HD-3030
RTTY Terminal Interface

Bulletin No:
HD-3030-1

Schematic Corrections - U3C & AFSK Board

Repetitive Failure Of CR6, Q10 and Q12

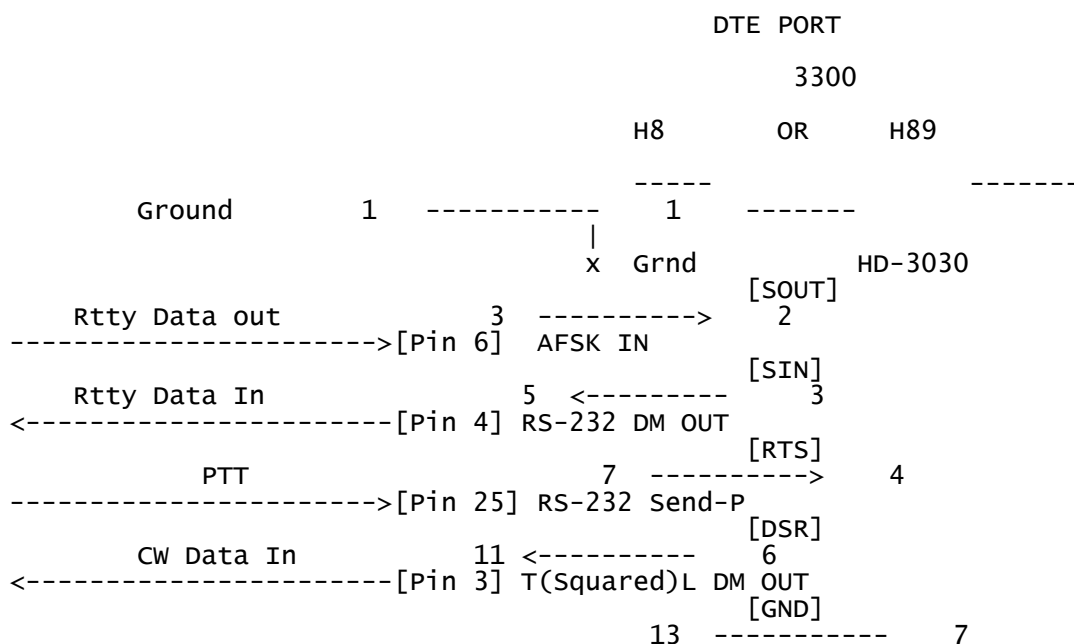
In Terminal Interface units set for current loop operation, the repetitive failure of CR6 [PN 56-16], Q10 [PN 417-936] and Q12 [PN 417-988] can be prevented by installing a normally-closed phone jack [PN 436-4] at S2 and a 110 volt zener diode [PN 56-48] across the loop output.

Make this change only when needed.

When the [PN 56-48] zener diode is installed according TEB HD-3030-2 in the 1984 TEB Book, the loop output won't function reliably when used as an input. To correct this problem, remove the #56-48 zener diode. When the shorting jack [PN 436-4] is installed and the criteria outlined in the "Caution" box on page 62 of the manual [PN 595-3100-2] is met, the zener diode is not needed.

Mark the change on TEB HD-3030-2 for future reference.
